MINOR VARIANCE REPORT

APPLICATION: A/105/2023 (deferred from July 26/23)

<u>Owner (s)</u>	<u>Agent</u>	<u>Location of Land</u>
L. JING H. LIU	LiJun Jing ProWise Engineering Inc. 308-2800 Skymark Mississauga ON L4W 5A6	PLAN 776 LOT 25 15 Forster Park Dr Town of Oakville

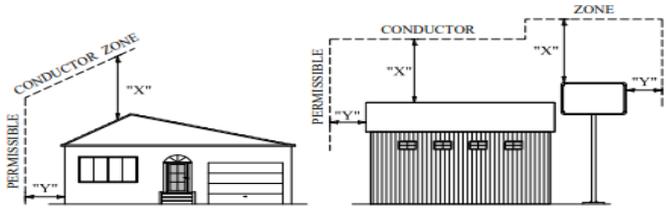
There is a poleline running along the west side yard and rear yard of 15 Forster Park Drive. This poleline provides electrical services to the properties along Forster Park Drive, North Forster Park Drive and Glenmanor Drive from the rear lot.

Minimum clearances between the proposed dwelling and the existing overhead poleline (horizontal and vertical, see enclosed Oakville Hydro STD.1-104 for details) need to be maintained at all times.

During construction, a minimum 4.0m clearance to low voltage conductors on the poleline should be maintained at all times.
